Corrigendum to “Interdependencies between physical, design and operational parameters for direct use geothermal heat in faulted hydrothermal reservoirs” [Geothermics, 86 (2020) 101806](S0375650519303785)(10.1016/j.geothermics.2020.101806)

Corrigendum to “Interdependencies between physical, design and operational parameters for direct use geothermal heat in faulted hydrothermal reservoirs” [Geothermics, 86 (2020) 101806]

Figure 9 Published.

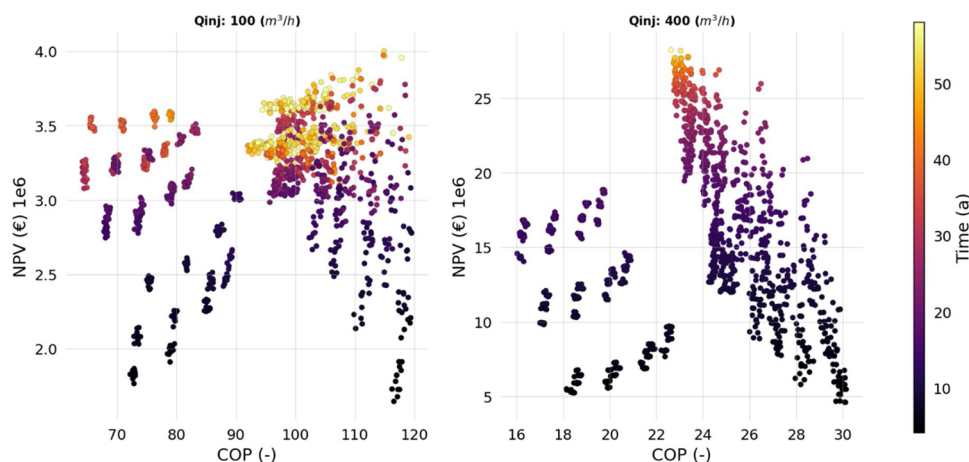
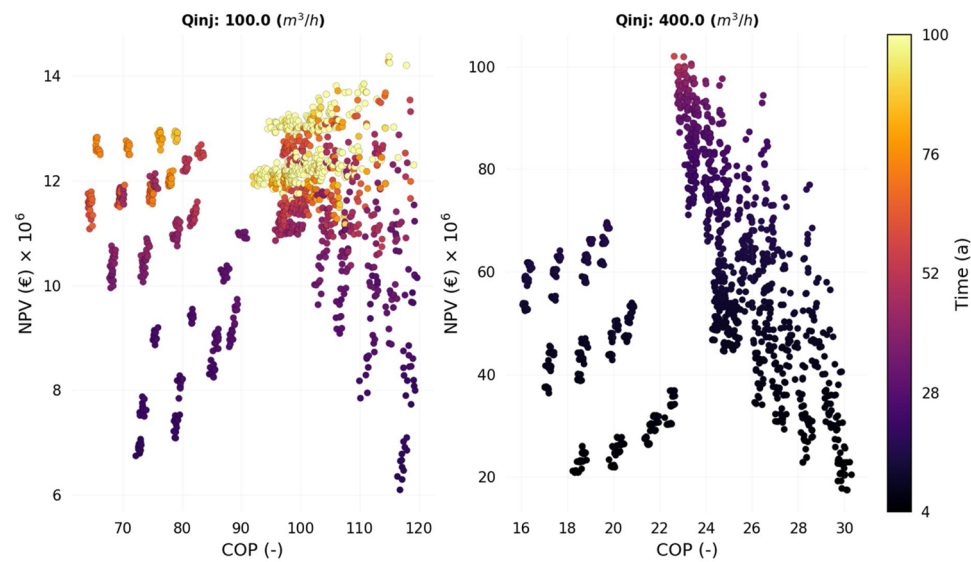
As the code was actively developed during the time of publication, the published data suffer from an error with regards to the discount factor applied during the NPV calculation. The published data NPV has been calculated for periods of 100 days, while the discount rate applied was the quoted Annual Discount Rate (ADR) value of the manuscript, namely 7%. When the NPV is calculated at intervals shorter periods than a year, the discount rate needs to be adjusted accordingly. This adjusted Periodic Discount Rate (PDR) should be calculated according to the following equation:

$$PDR = (1 + ADR)^{period/year} - 1$$

For our data this means that the PDR should be 0.018697 or

1.8697% for each period of 100 days for which the NPV is calculated.

This was not done for the published data, due to different versions of the code being used. As a result, the time value of money was discounted much more than it should be (7% each 100 days when it should be 1.8697% per 100 days), leading to lower NPV values. This affects section 3.3 “Lifetime and NPV” of the published article (Figures 9, 10 and 11). We have re-performed the processing after having addressed this issue and plotted the corrected data in the updated figures below. While the qualitative conclusions that were drawn from the published figures are not significantly different from the corrected ones, the quantitative NPV values of the corrected figures differ substantially.

Figure 9 Corrected.
